Re: Turkey Point Units 3 and 4  
Docket Nos. 50-250 and 50-251  
Response to NRC Request for Additional Information Regarding  
Extended Power Uprate License Amendment Request No. 205 and  
Reactor Systems Issues

RESPONSE TO NRC RAI REGARDING EPU LAR NO. 205  
AND SRXB REACTOR SYSTEMS ISSUES

**Figure SRXB-1.3.11-1**  
**Steam System Piping Failure at Hot Zero Power – 1.388 ft<sup>2</sup> Break**  
**with Offsite Power Available and without Accumulator Boron Credited**  
**Nuclear Power and Reactivity vs. Time**

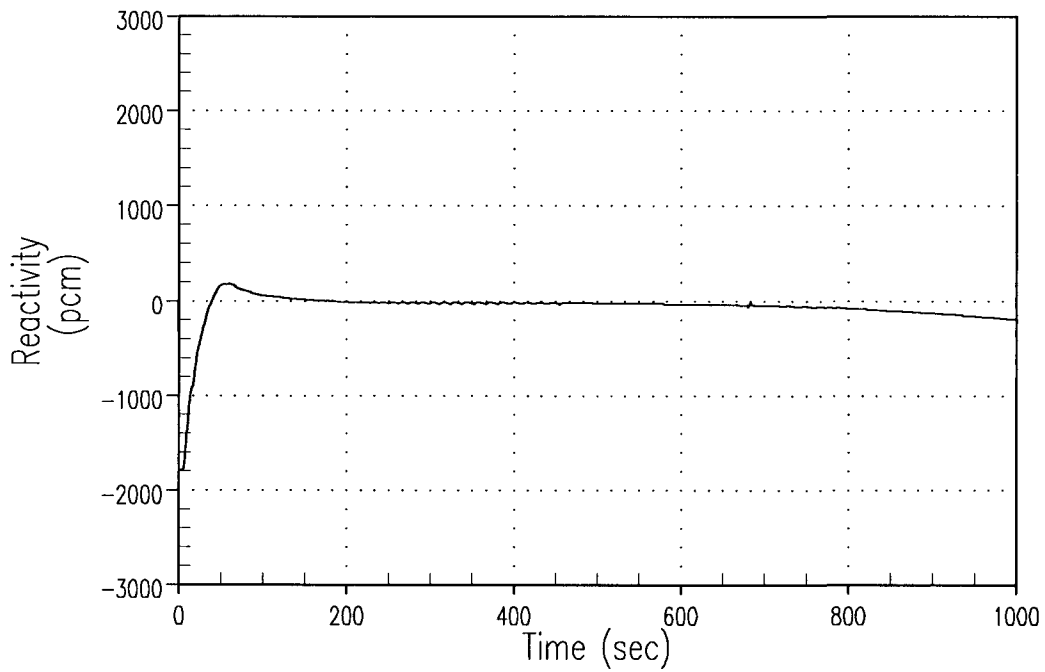
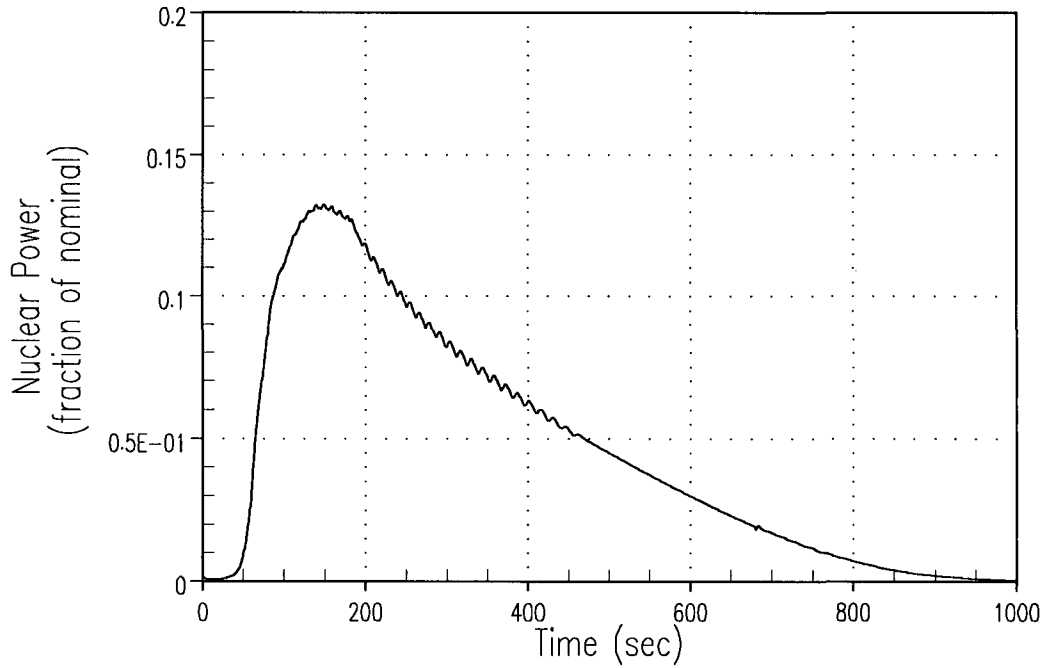
**SRXB-1.3.11** Table 2.8.5.1.2.2.1-1 indicates the core becomes subcritical at 186.25 seconds. Why is nuclear power still being generated, at a rate greater than 3%, more than six minutes after the core becomes subcritical?

The negative reactivity insertion resulting from the addition of boron to the core from the SI flow injection does cause the core to become subcritical by 186.25 seconds. However, given the conservatively low boron worth and SI flows assumed, the rate of change of reactivity is relatively slow and it is not until later in the transient that the overall reactivity of the core begins to decrease well below the point of criticality (see Figure SRXB-1.3.11-1). As such, it is also not until later in the transient that nuclear power approaches zero (see Figure SRXB-1.3.11-1). If the addition of boron from the accumulators had also been credited in the analysis, then the overall reactivity and nuclear power response would have decreased at a much faster rate (see Figure SRXB-1.3.11-2).

**Figure 1.3.14-1 - Simplified sketch of the shared HHSI system. (“S” identifies components that automatically change state on SI signal – i.e., valves open and pumps start)**

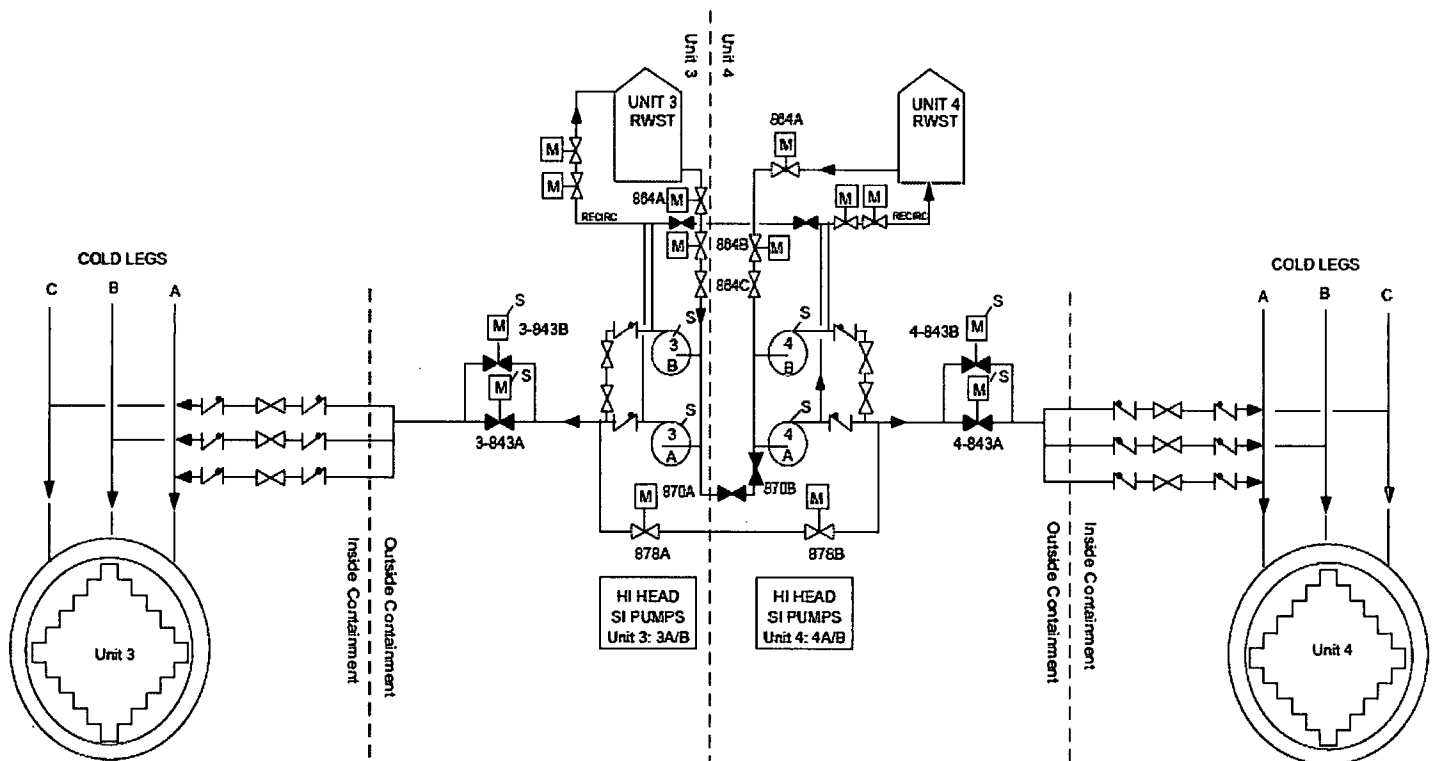
**c. If an SI signal is generated in one unit, what is the destination of the SI flow that is pumped in the other unit?**

If a SI signal is generated on one unit, both units’ HHSI pumps will start. As shown in Figure 1.3.14-1, the HHSI pump discharges are cross-connected between the two units. The SI signal opens only the accident unit’s cold leg injection valves, so all four HHSI pumps will deliver injection flow to the unit that generated the SI signal. Since the SI signal only opens the accident unit’s injection valves, no SI flow is delivered to the non-accident unit.

Figure 1.3.14-2

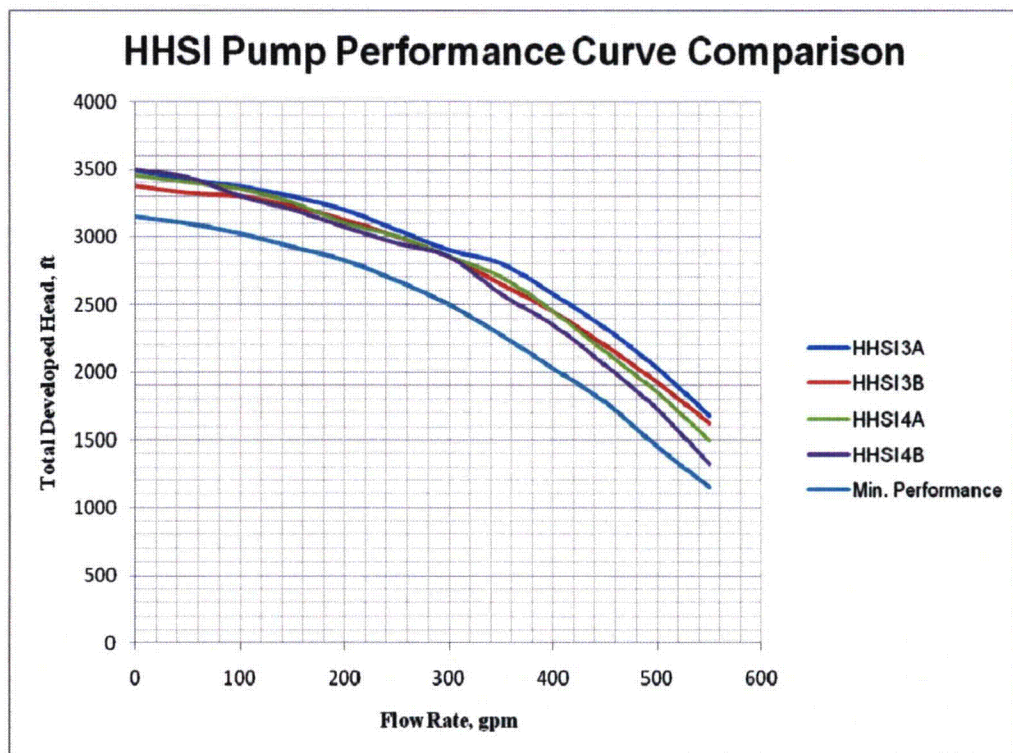
**d. Why are the HHSI pumps assumed to be operating on degraded performance curves? Provide the degraded performance curves. Compare the degraded performance curves to the design performance curves.**

The minimum (degraded) performance curve shown in Figure 1.3.14-2 is used in the Emergency Core Cooling System (ECCS) analysis for all four HHSI pumps. The design performance curves for each of the four HHSI pumps are also shown in Figure 1.3.14-2.

The analysis conservatively assumes a minimum (degraded) performance curve to minimize the rate of negative reactivity injected to the core from the higher boron concentration of the Refueling Water Storage Tank (RWST) in the analysis of the Rupture of a Steam Pipe (Licensing Report (LR) Section 2.8.5.1.2) and to minimize core cooling flow in the analysis of Loss of Coolant Accident (LR Section 2.8.5.6.3). The ECCS minimum flow calculation assumptions include identifying the minimum (degraded) performance curve which identifies a lower pump head and flow curve to minimize core flow. The pump minimum (degraded) performance curve is degraded to be consistent with the plant pump surveillance procedures. These procedures account for Emergency Diesel Generator (EDG) underfrequency, pump degradation, etc. The minimum degraded pump curves are analytical limits which establish lower pump performance limits for acceptable operation for the installed plant pumps. There is no regulatory guidance to degrade the minimum performance curve.
